Addendum No. 1
December 6, 2022

Shared Use Path on SR270 to Stadium Way
Pullman, WA

Project No.9705-2018
Washington State University
Facilities Services, Capital

**Shared Use Path on SR270 to Stadium Way
Washington State University
Pullman, WA**

C-001

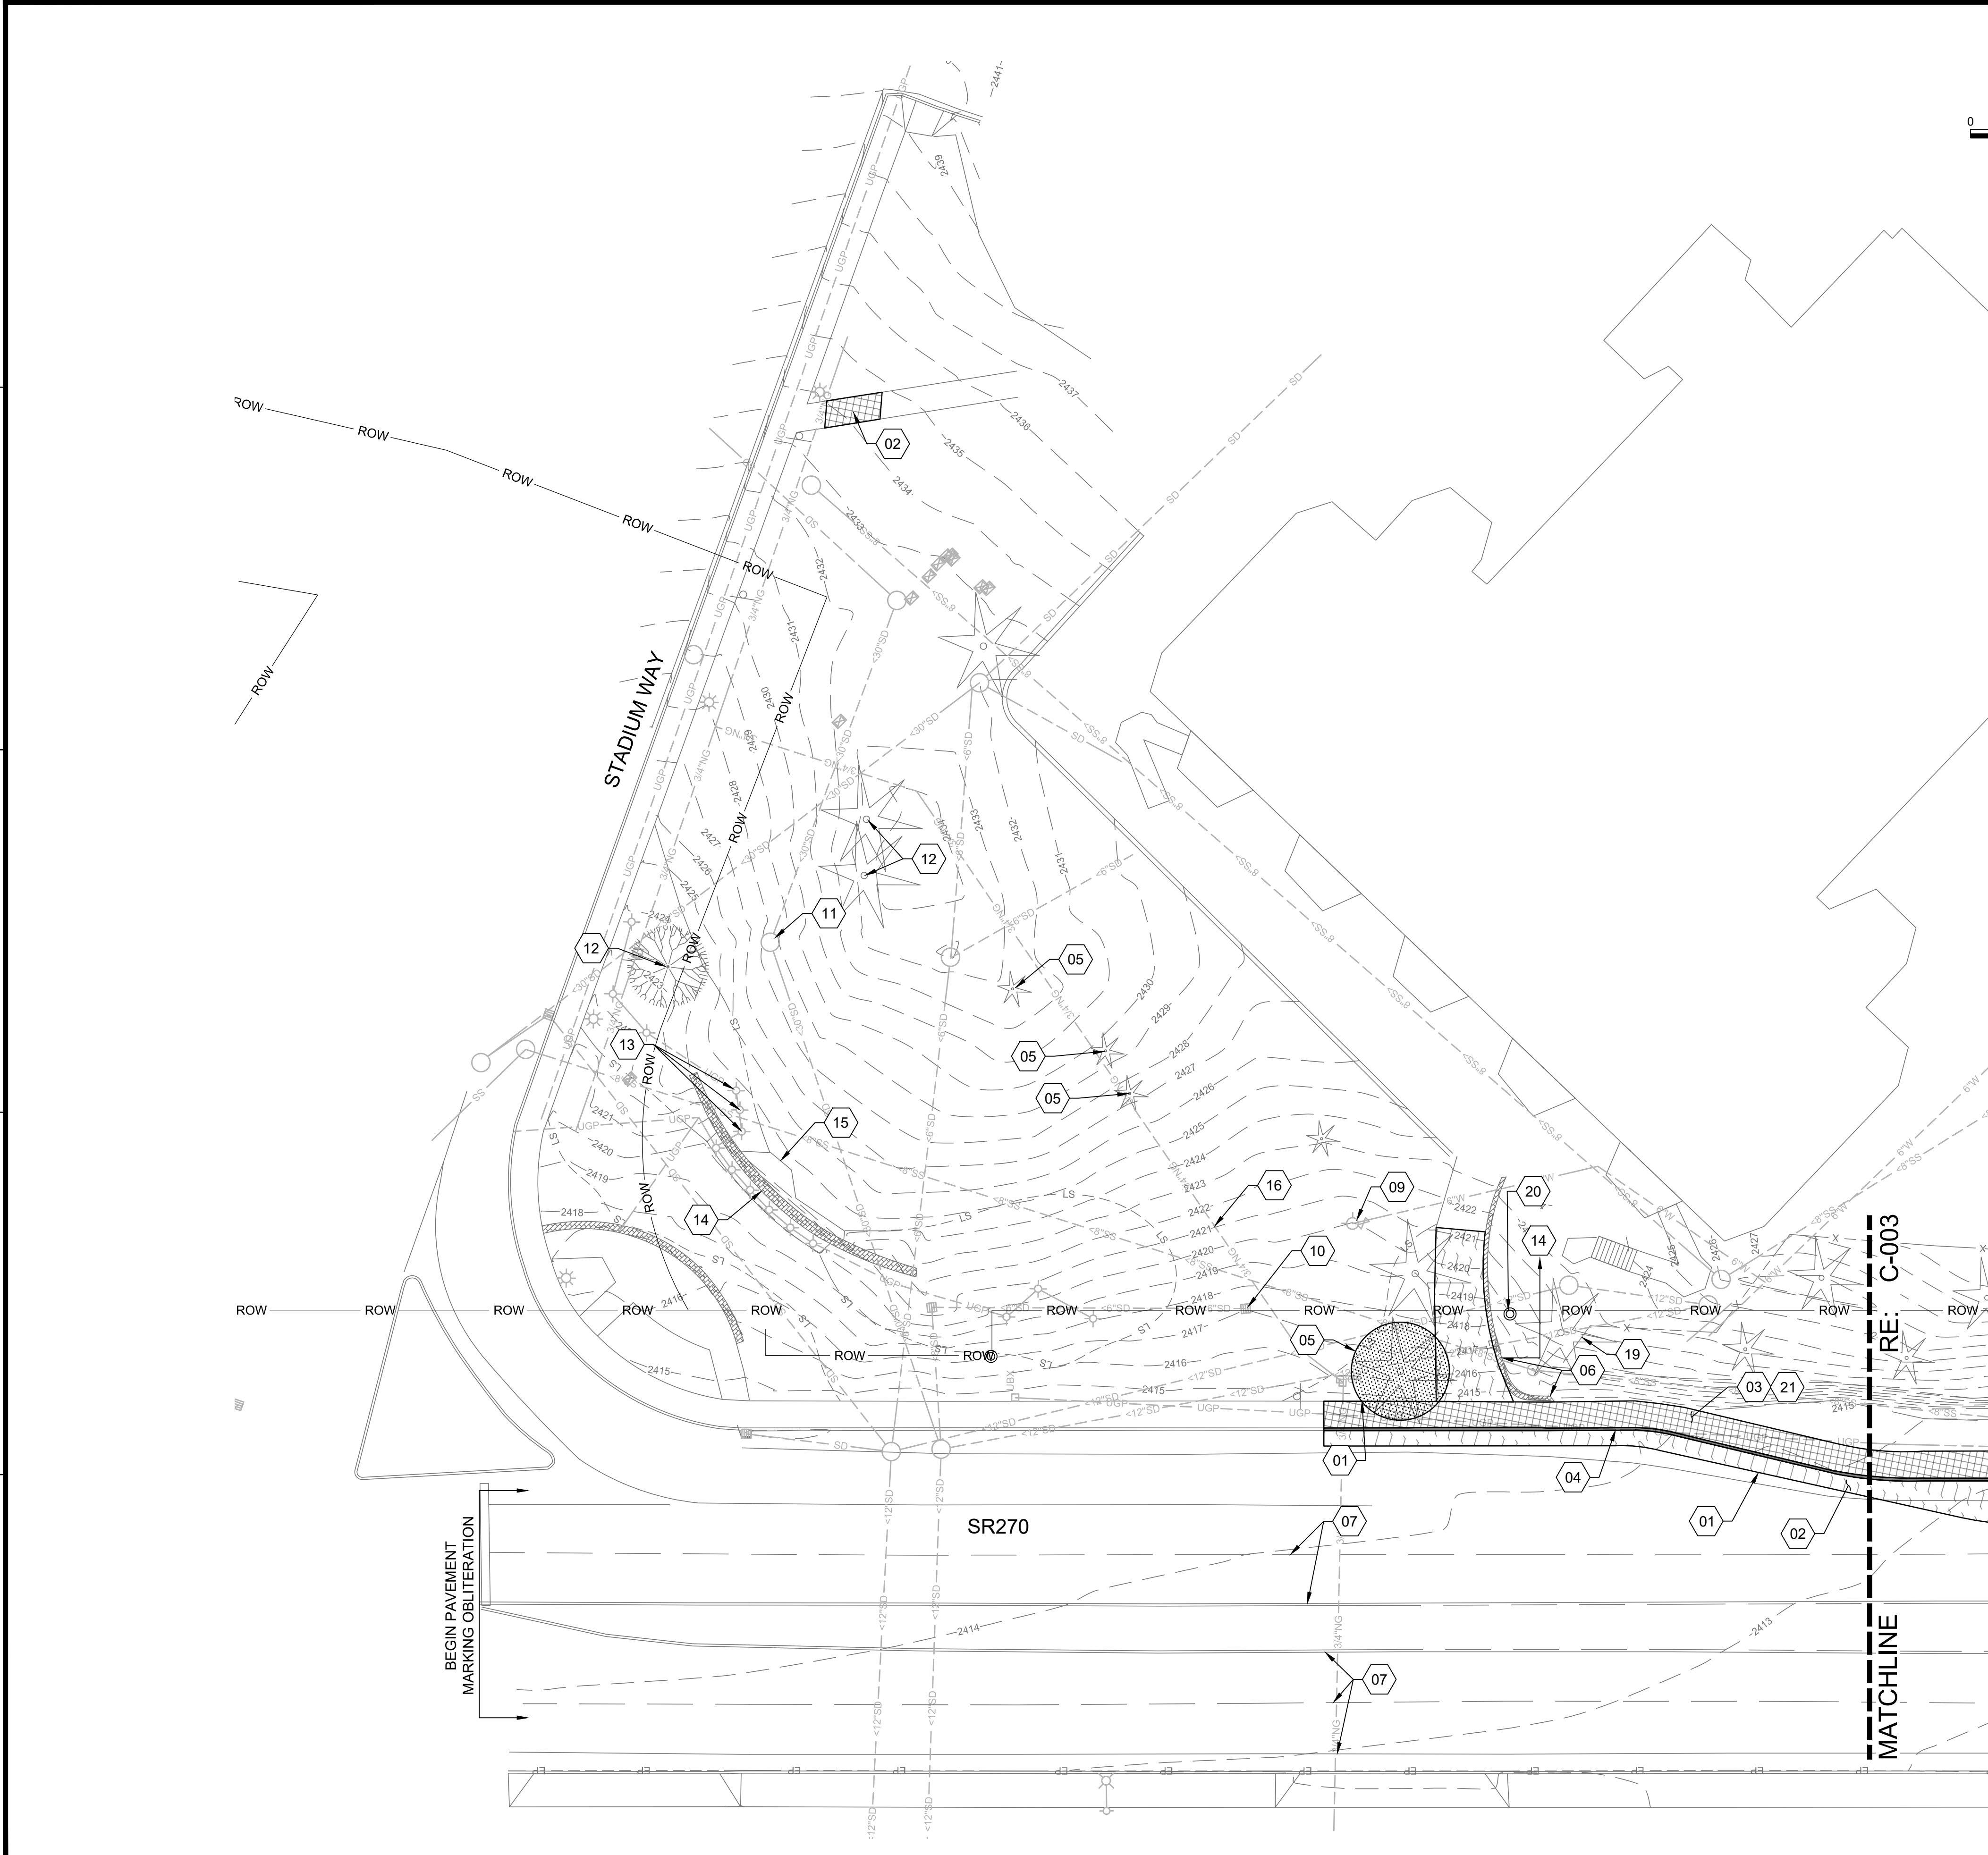
DWG 1-1. Drawing C-001 – Erosion & Sediment Control Plan

Item 1. Remove and replace entire drawing.

C-002

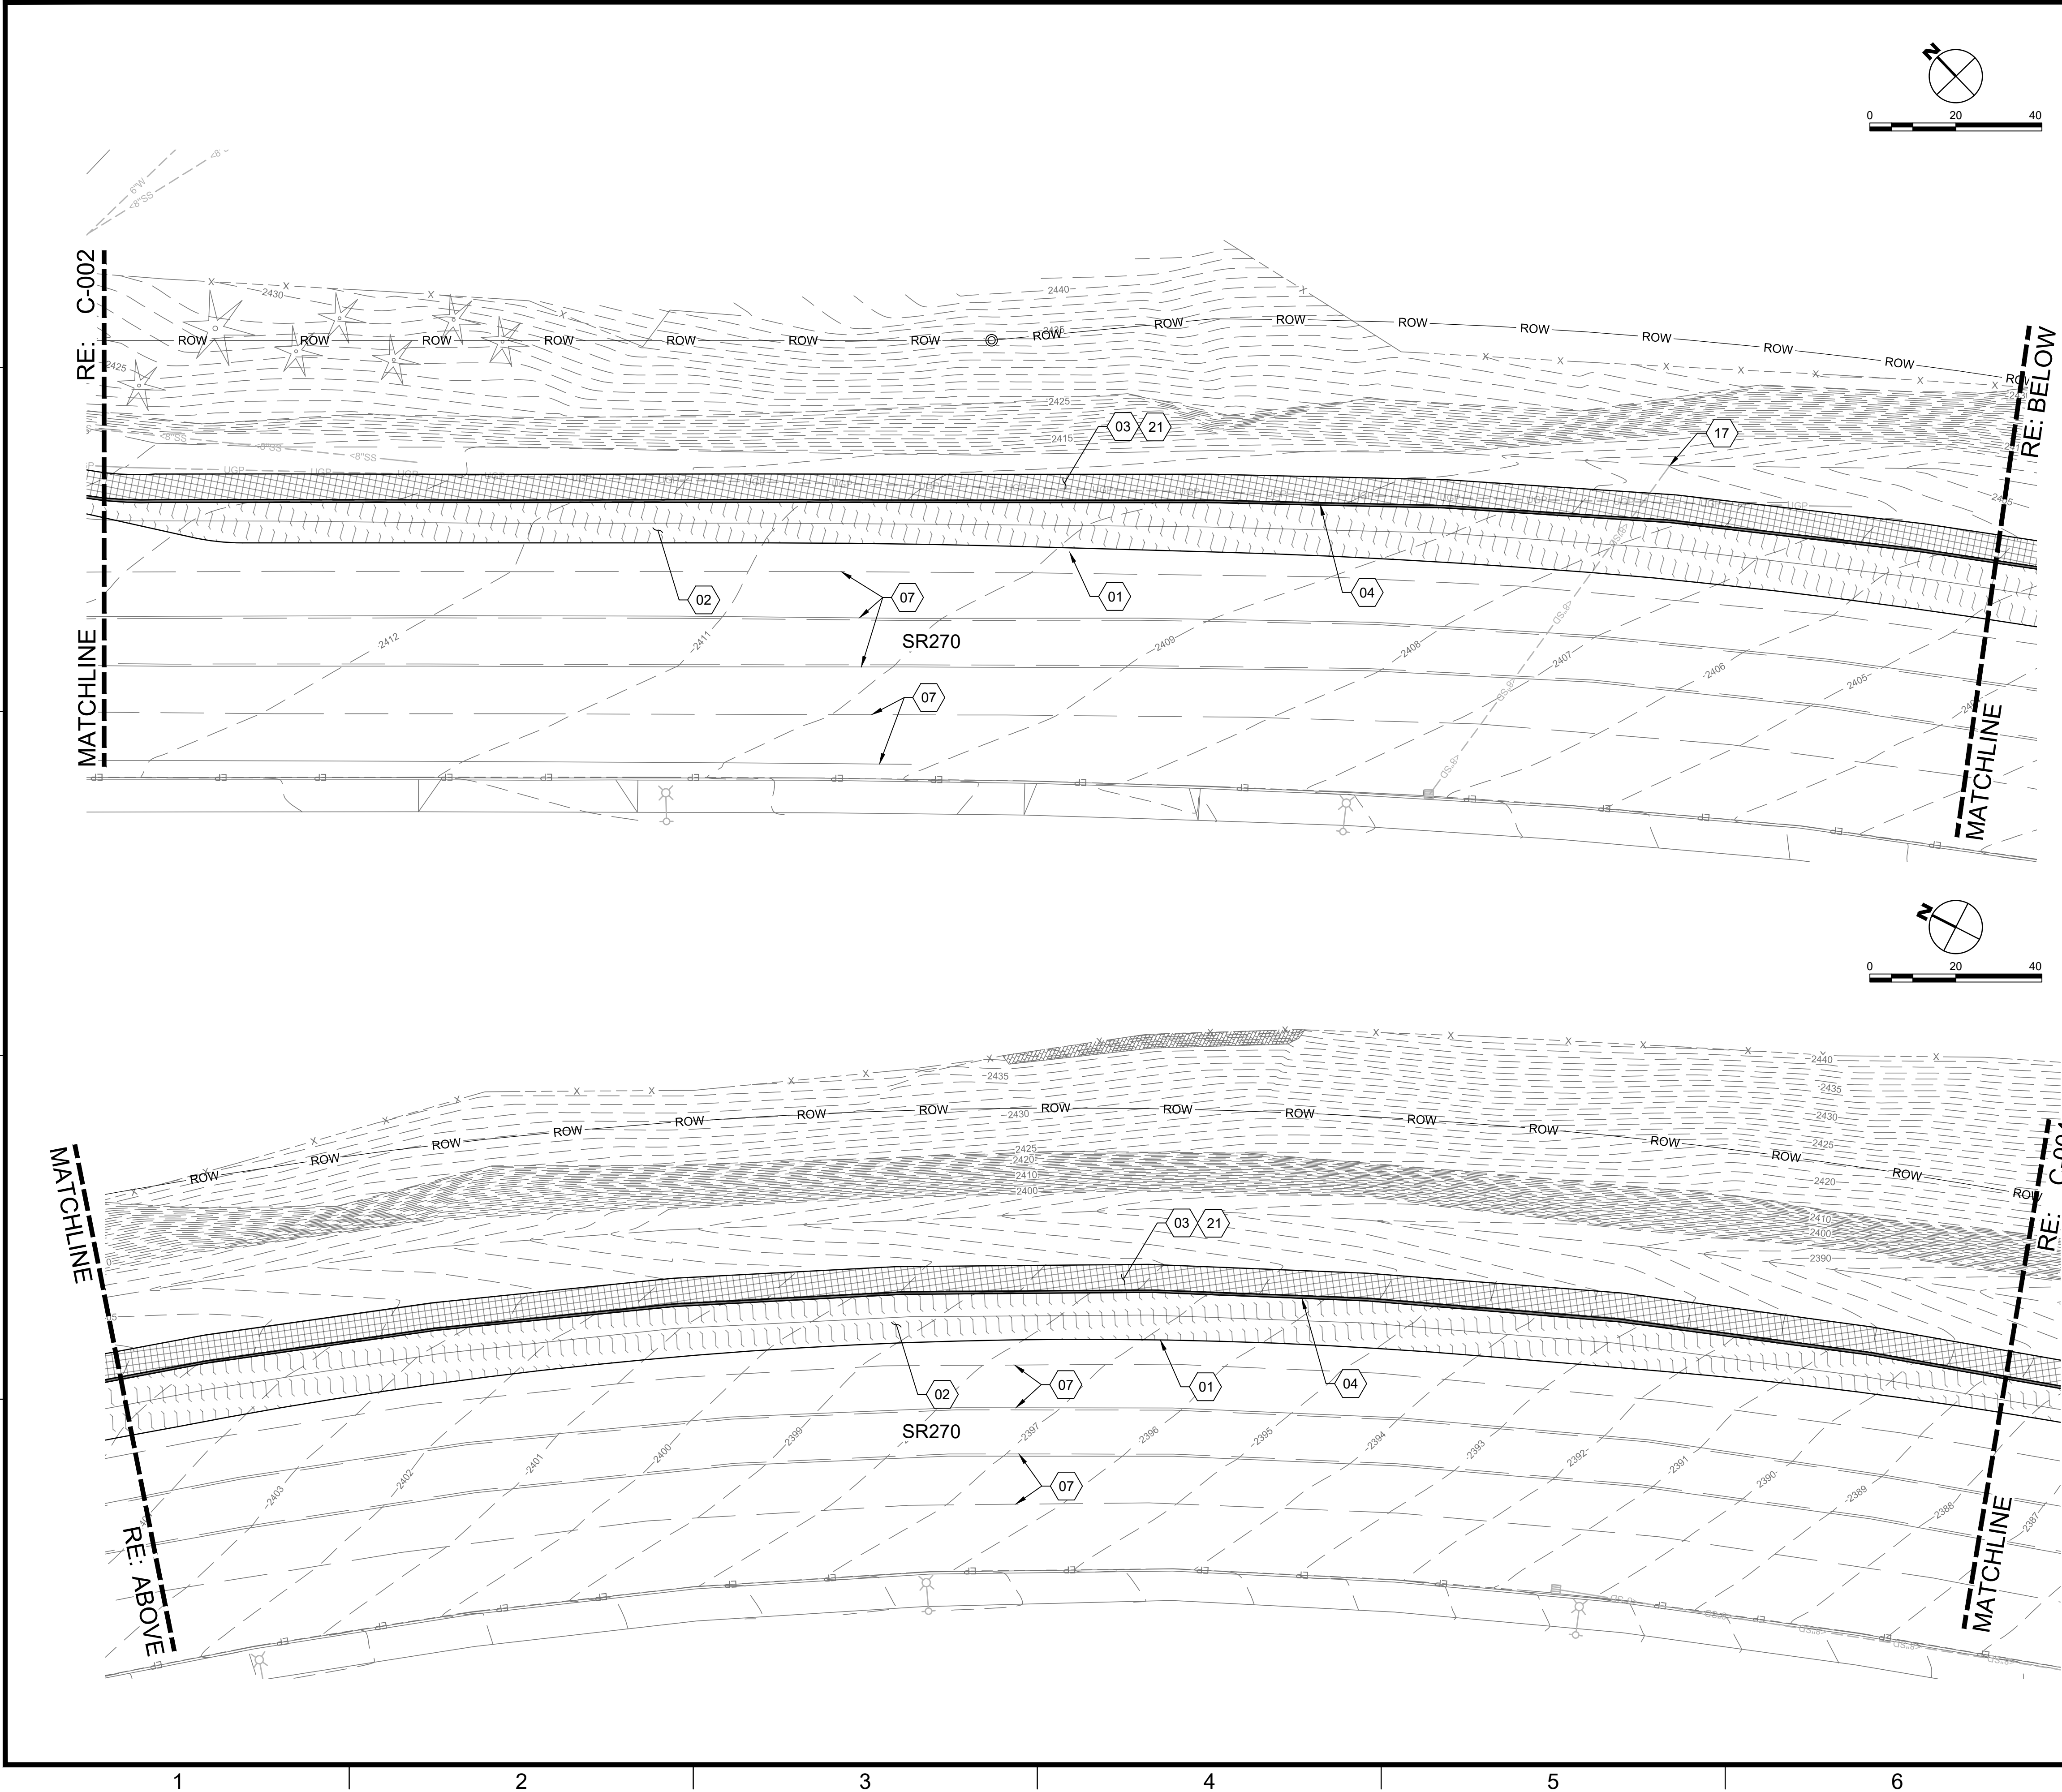
DWG 1-2. Drawing C-002 – DEMO PLAN (STA. 1+00 TO 4+40)

Item 1. Remove and replace entire drawing.

MARK	DATE	DESCRIPTION
1	11/29/22	BMP ADDITIONS, ADDENDUM #1

DEMO PLAN
STA. 14+20 TO END

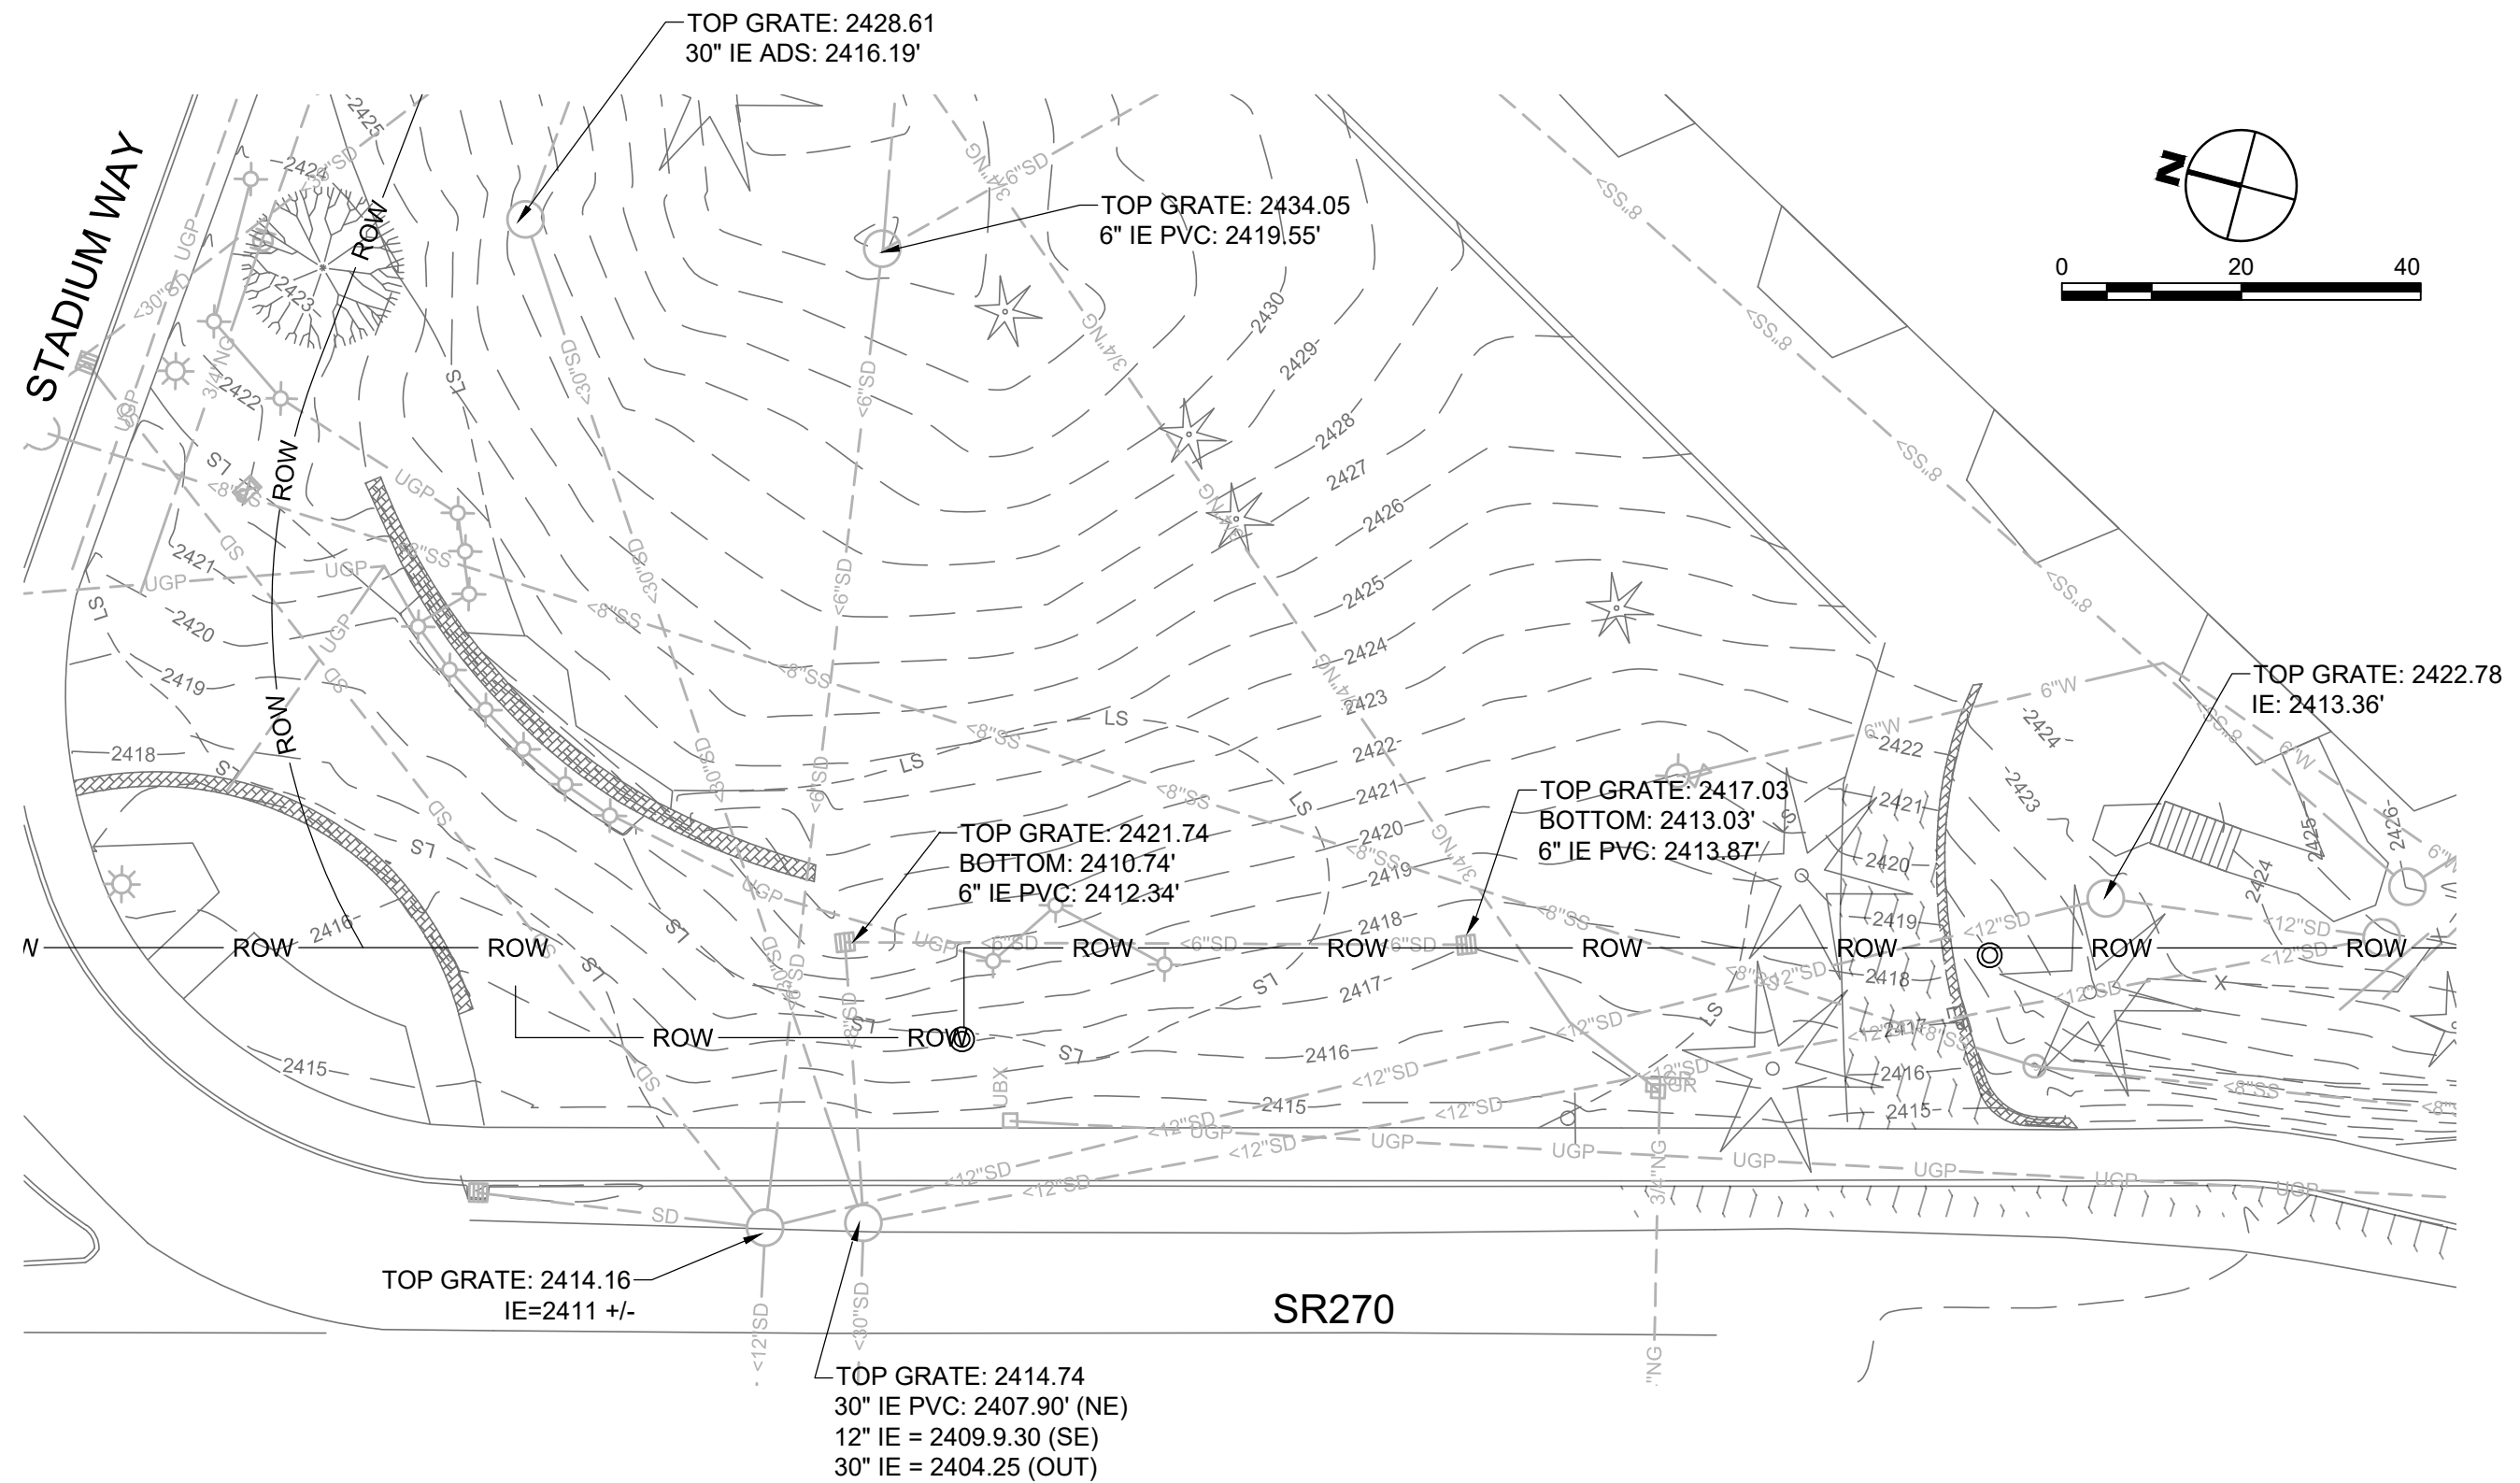
DWG 1-4. Drawing C-004 – Demo Plan (STA. 14+20 TO END)

Item 1. Remove and replace entire drawing.
